Commonwealth Edison

September 8, 1981

Subject: LaSalle County Station Units 1 and 2
Diesel Generator and ECCS
System - FSAR Changes
NRC Docket Nos. 50-373/374

Attached is a set of changes to the FSAR (pp. 6.3-40, 43, 43a, 7.3-17, 8.3-8, 8a, 9, 9a, 9.5-20, 29, 29a, -32, B.1-12, 12a, 13, response to NRC Questions Q40.29 and Q40.30. Also, three tables and Tech Spec pages 3/4 8-1 to 3/4 8-7 and B3/4 8-1, which are not for inclusion in the FSAR, are attached.

FIGURE 1E-1-4009AA

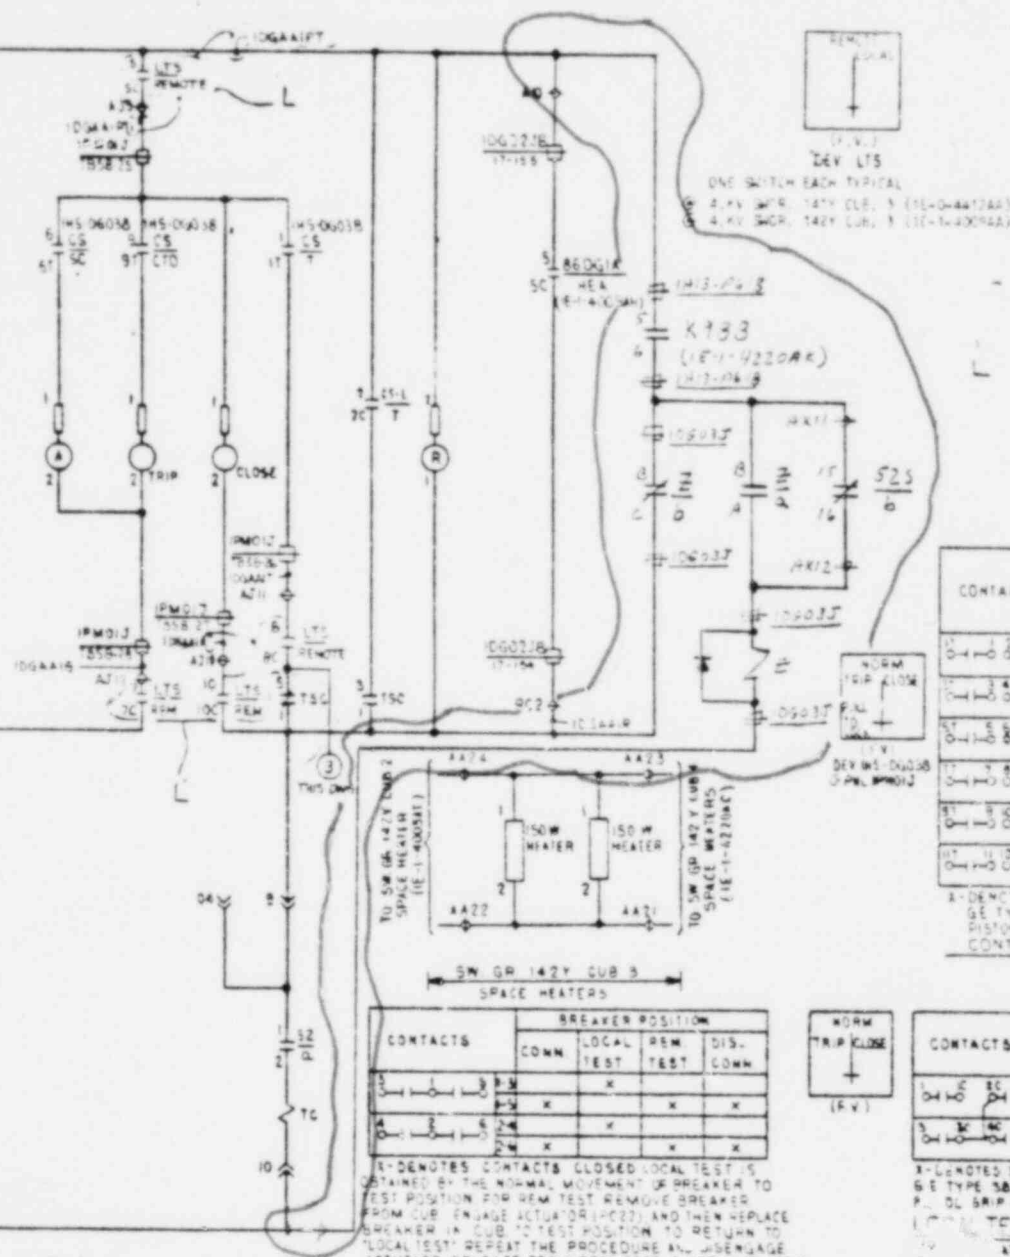
The diesel generator output breaker circuitry has been revised to incorporate a one-time trip of the breaker upon receipt of a LOCA signal under any operating condition, including test. The FSAR has been revised to reflect this change. Minor corrections to the diesel control descriptions have also been made.

LOCA TRIP ADDITION

SCHEMATIC DIAGRAM - 4160-V SWITCHGEAR
142Y DG 1A FEED ACB 1423 SYSTEM
(DG) PT. 1

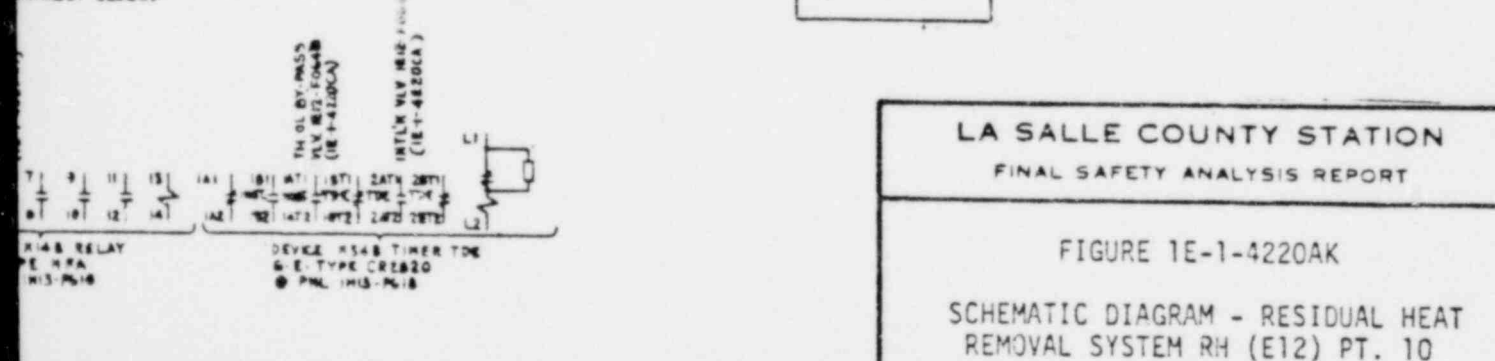
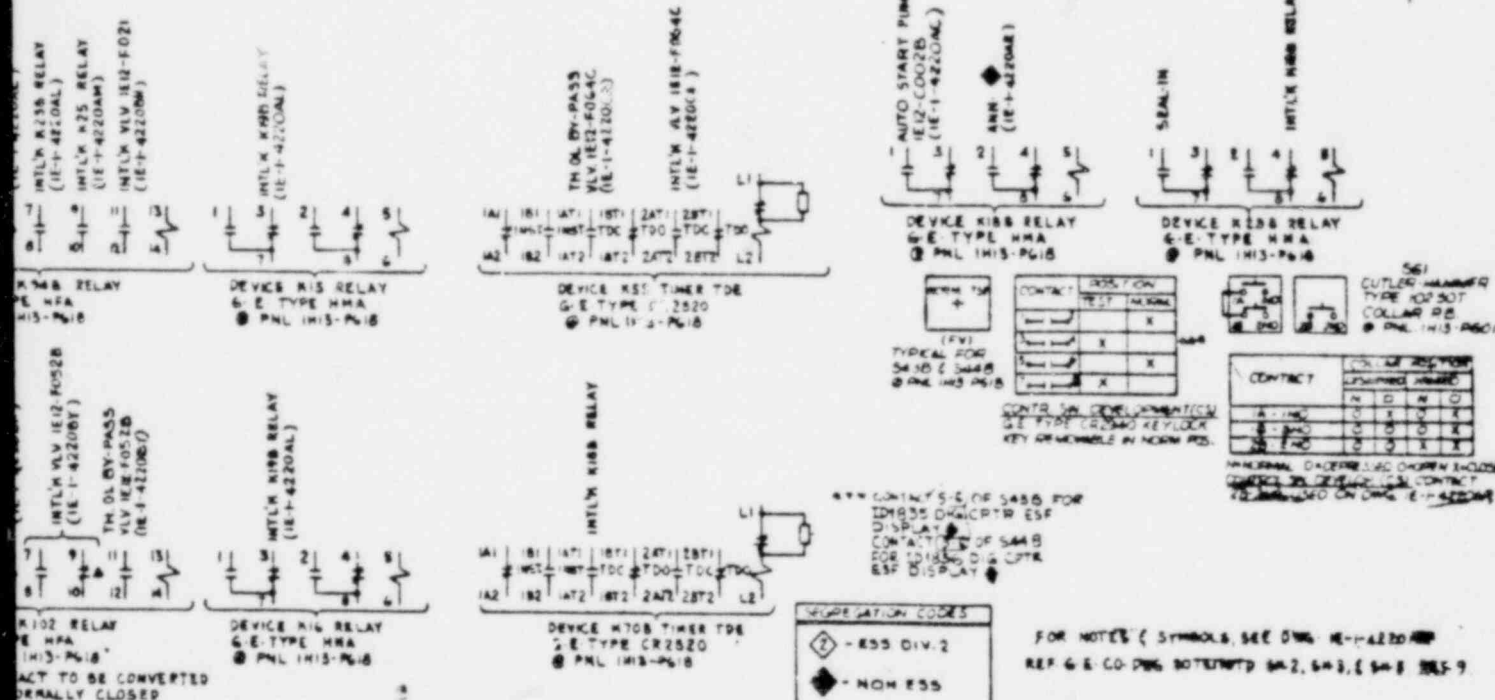
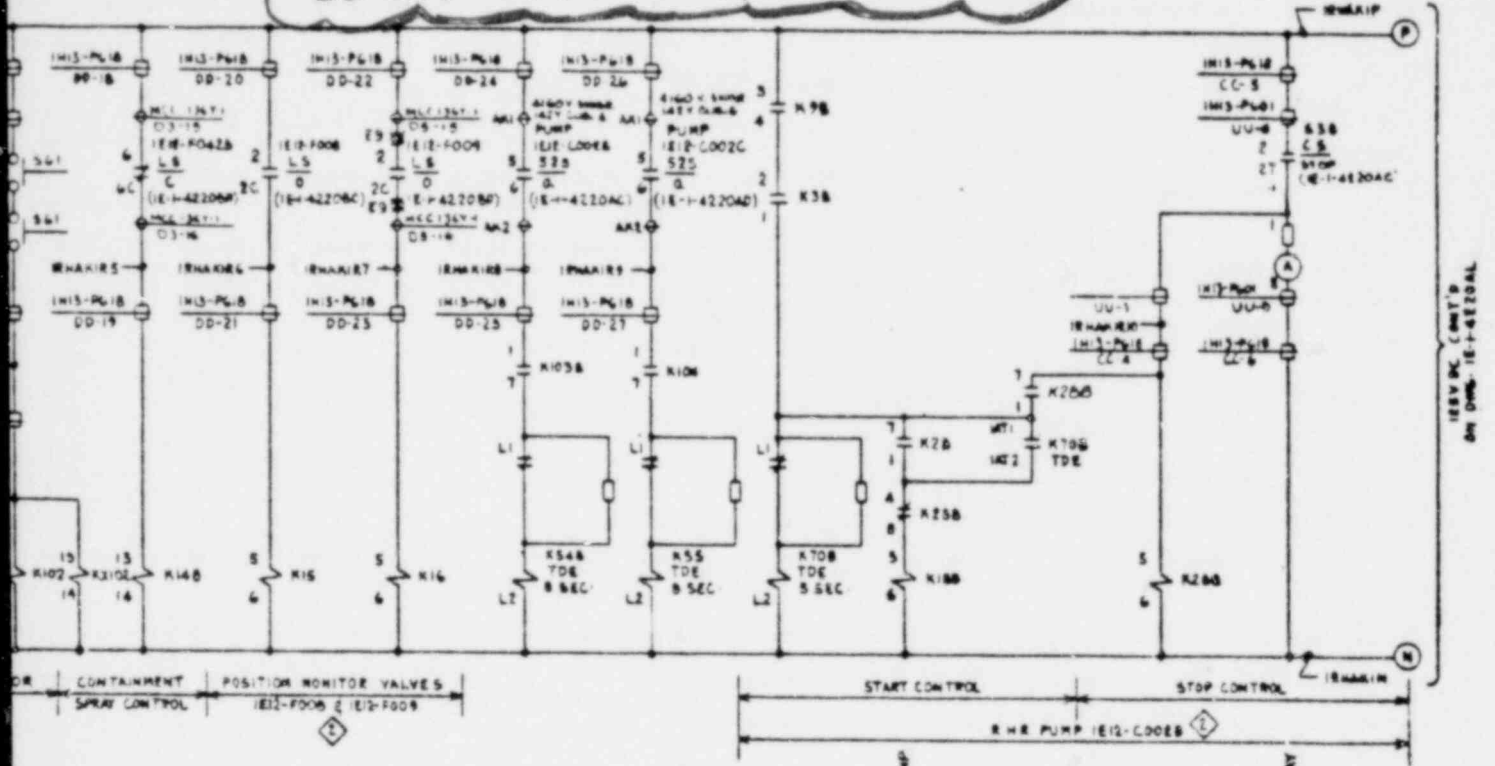
LOCA TRIP ADDITION
